RIVERSIDE CENTEI PARKING DECK

UTILITY PLAN
AREA B

CS103B

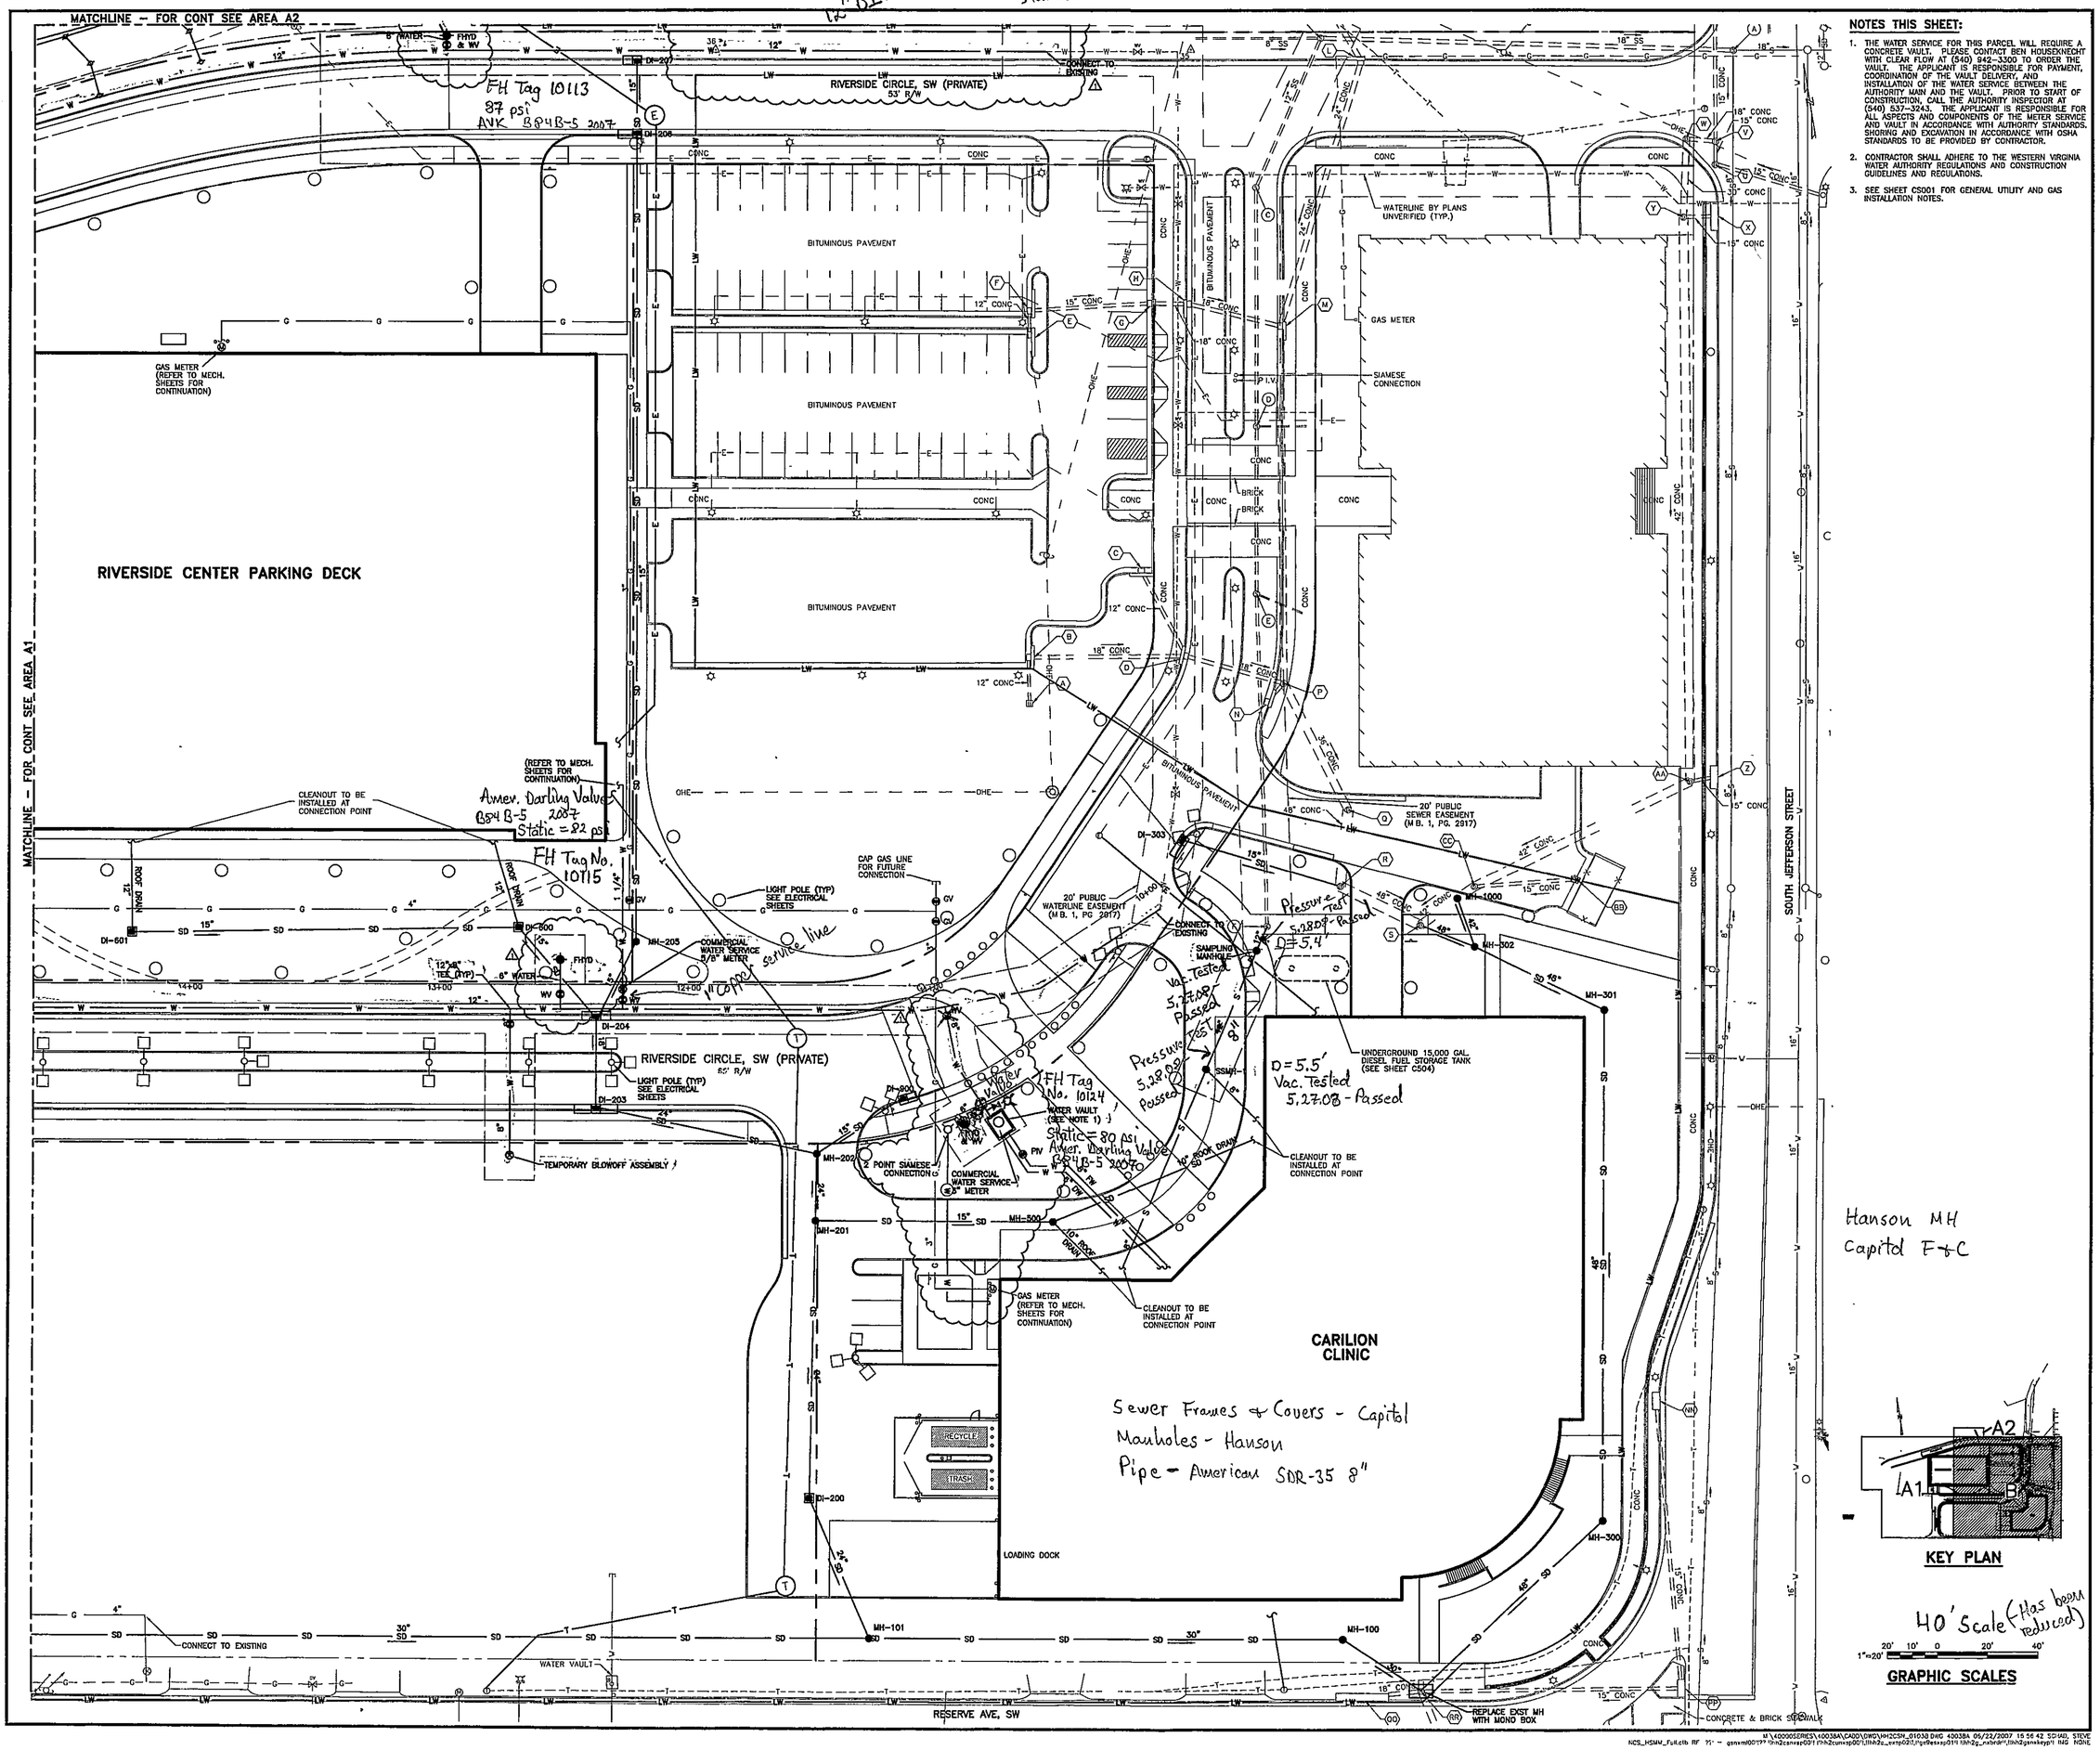
12" DIP

started 11/21/06

C202 - 7/17/07
Calls for 8" sewer line, not 12".
